M24C64S-FCU package mechanical data modifications

This errata sheet applies to the M24C64S-FCU, that is the 64 Kbit serial I²C bus EEPROM delivered in WLCSP four balls.

Figure 3. D and E back side view

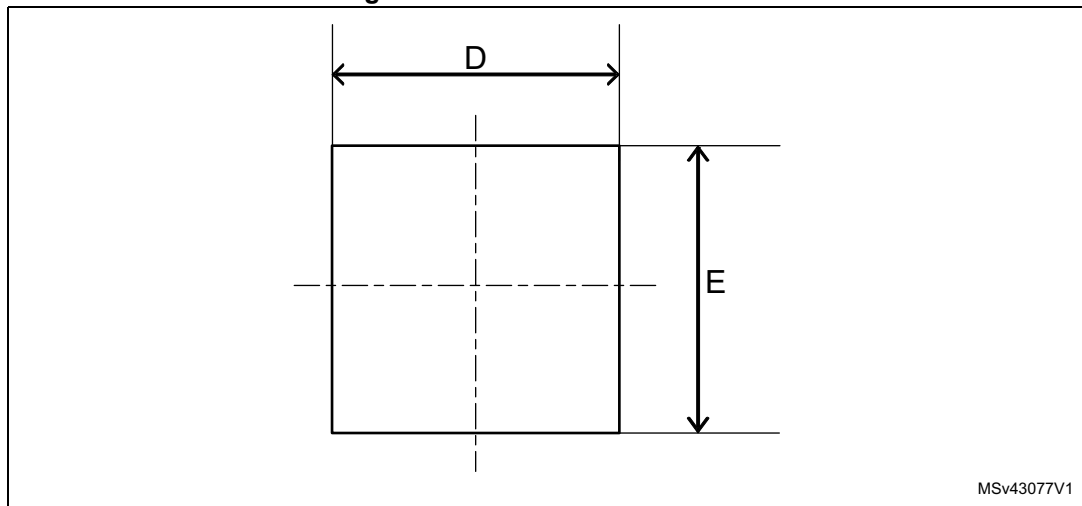
This document refers to the changes of dimensions D and E (see [Figure 3](#)) described in the M24C64S-FCU datasheet, in tables detailing the dimensions of the Ultra Thin WLCSP 4-bump package.

D and E values must be modified to correct the following mistake:

- The D and E values on M24C64S-FCU datasheet corresponding to front side view (ball side) as shown in [Table 2](#), instead of back side view (marking side view) as shown in [Table 3](#).

Symbol	Millimeters			Inches		
	Min	Typ	Max	Min	Typ	Max
D	0.831	0.851	0.871	0.0327	0.0335	0.0343
E	0.831	0.851	0.871	0.0327	0.0335	0.0343

Figure 4. D or E side view

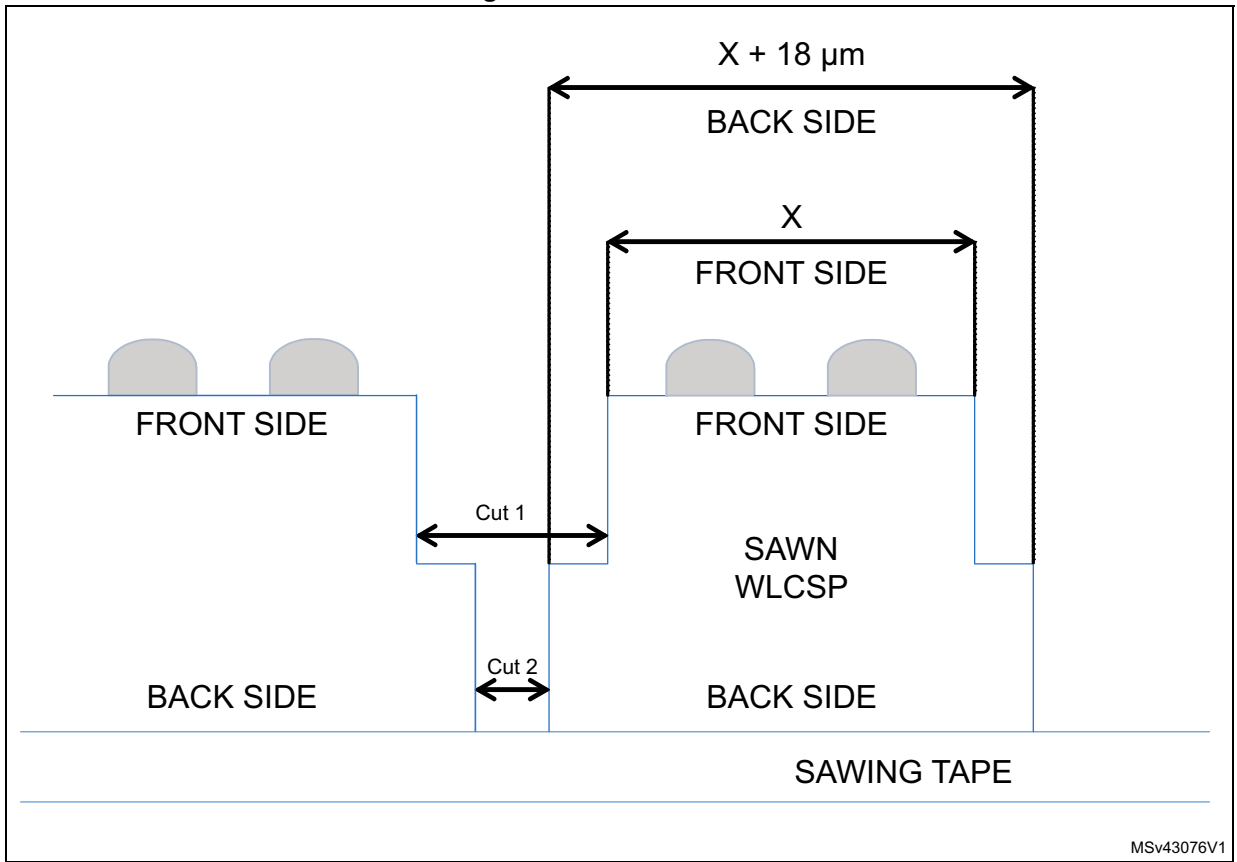
The difference between back side and front side dimension is 18 μm (0.018 mm). This difference is due to two-step sawing process, where cut 1 and cut 2 are performed with blades having different thickness (see [Figure 4](#) in which X represents D or E and it has the same value and tolerance).
